# CITY OF ALBUQUERQUE

**Re: Dutch Bros**  
**2501 Juan Tabo NE**  
**Traffic Circulation Layout**  
Engineer's Stamp 10-24-22 (H21-D004A)

Based upon the information provided in your submittal received 11-02-22, the above referenced plan cannot be approved for Building Permit until the following comments are addressed:

**CP-401**

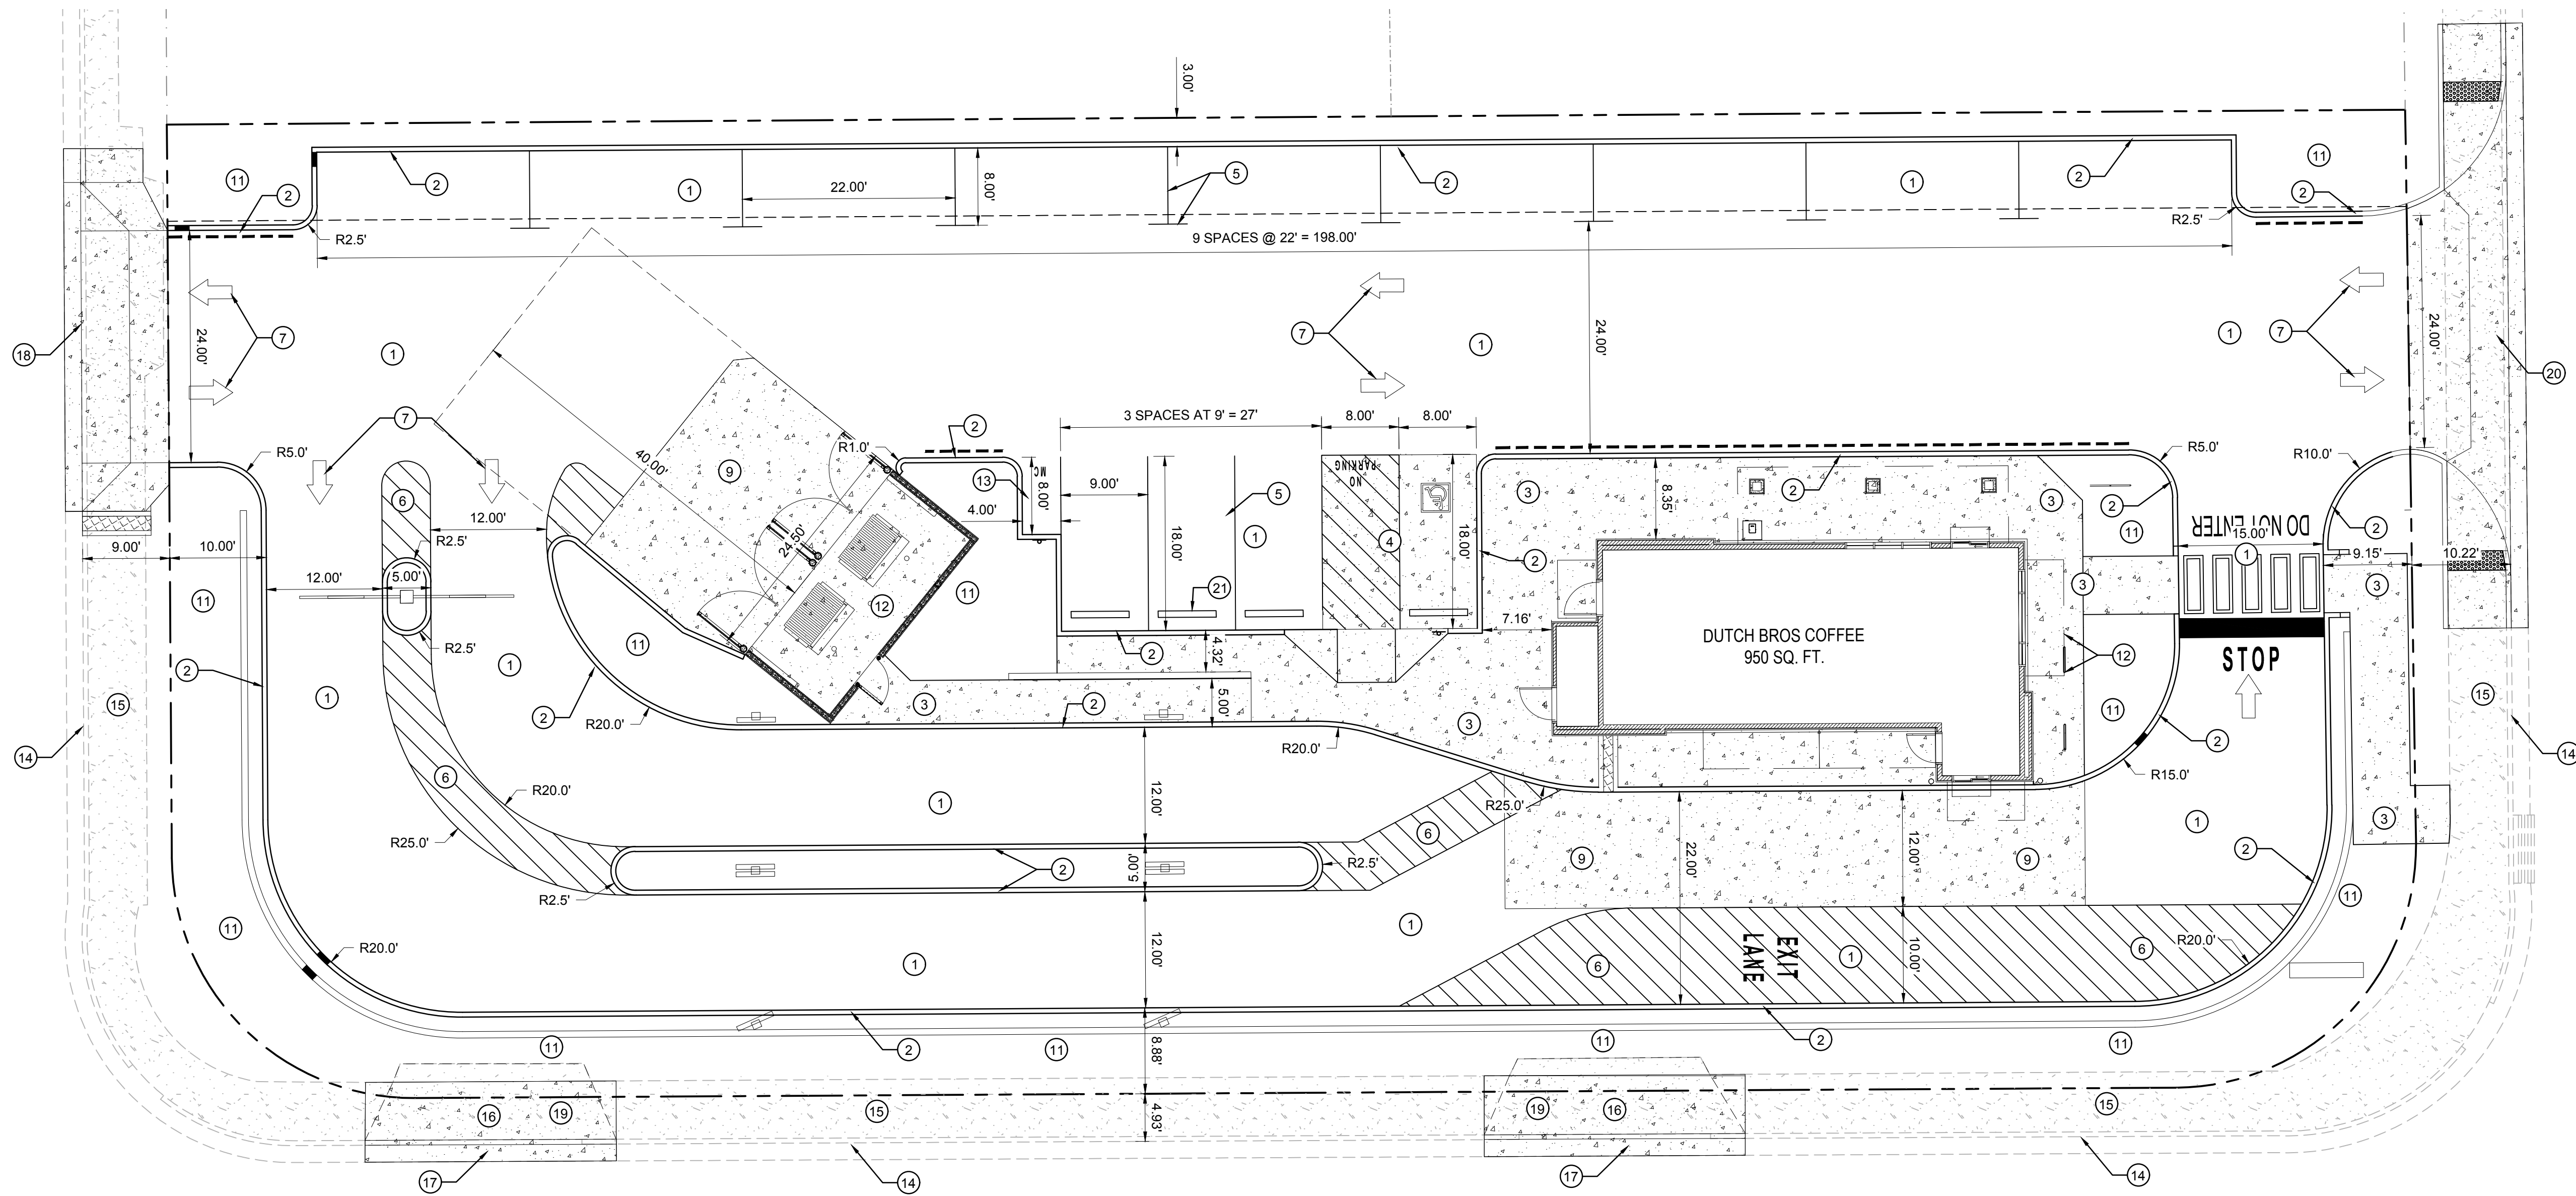
1. Please show a vicinity map showing the location of the development in relation to streets and well known landmarks.
2. Identify the right of way width, medians, curb cuts, and street widths on Juan Tabo Blvd, Phoenix Ave. and Muriel St. NE.

3. Per the DPM Table 7.4.46, Driveway access off Juan Tabo should be 150 ft. away from the intersection of Juan Tabo and Phoenix. Please clearly show this dimension on the site plan.

4. List radii for curves for driveway access off Juan Tabo; for passenger vehicles. Radius for delivery trucks, fire trucks, etc. is 25 ft. or larger.
5. Minimum throat length for this site should be 50 ft. please show this dimension on the site plan.

6. Minimum width for the ADA parking space is 8.5 ft.
7. Driveway access off Muriel should be built as a curb return design (per COA std dwg 2426) and provide the radius.

8. ADA curb ramp at the corner of Juan Tabo Blvd. and Phoenix Ave. must be updated to current standards and have truncated domes installed.
9. ADA curb ramp at the corner of Phoenix Ave. and Muriel St. must be updated to current standards and have truncated domes installed.

10. Please show 12 cars are stacking in the drive-thru lanes on the site plan.
11. All bicycle racks shall be designed according to the following guidelines:

15. Per the IDO, a 6 ft. wide ADA accessible pedestrian pathway is required from the public sidewalk to the building entrances. Please clearly show this pathway and provide details.

16. Per DPM, a 6 ft. wide ADA accessible pedestrian pathway is required from the ADA parking stall access aisles to the building entrances. Please clearly show this pathway and provide details.

- PO Box 1293
17. Refuse vehicle maneuvering shall be contained on-site. The refuse vehicle shall not back into the public right of way. provide a copy of refuse approval.

- Albuquerque
18. Provide a copy of Fire Marshal approval.
  19. Please provide "One Way" and "Do Not Enter" signage. And provide face signs details.
  20. Please provide a sight distance exhibit

- NM 87103
21. Show the clear sight triangle and add the following note to the plan: "Landscaping and signage will not interfere with clear sight requirements. Therefore, signs, walls, trees, and shrubbery between 3 and 8 feet tall (as measured from the gutter pan) will not be acceptable in the clear sight triangle.

- www.cabq.gov
22. Please specify the City Standard Drawing Number when applicable.
  23. Add a note stating "All broken or cracked sidewalk must be replaced with sidewalk and curb & gutter." A build note must be provided referring to the appropriate City Standard drawing.
